Access Compliance Report
Public Rights-of-Way
(Curb Ramps)

Intersection ID: 15005	Main Street: ARENA_BV	Cross Street: TELEVISION_PL	Location:	E
ADA ID: C4C2CD181EE8	Ramp Type: Para	Initial Pass/Fail: Fail	Overall Compliance: No	Severity Score: 25

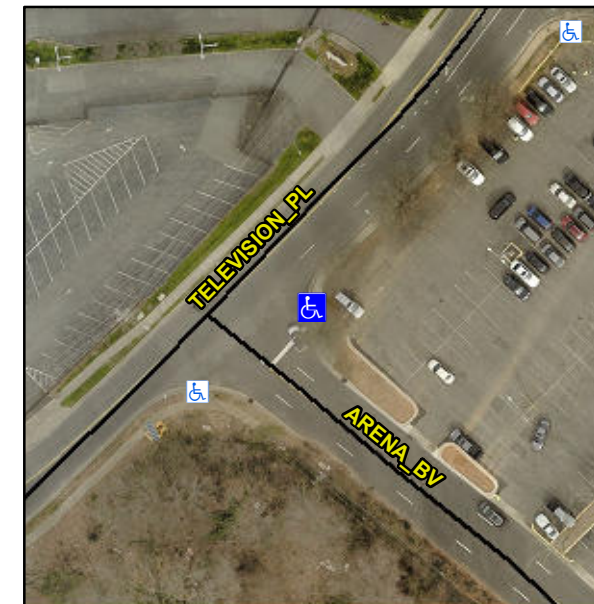
LT RP < 5%

R304.3.2

Remove & Replace Entire Ramp.
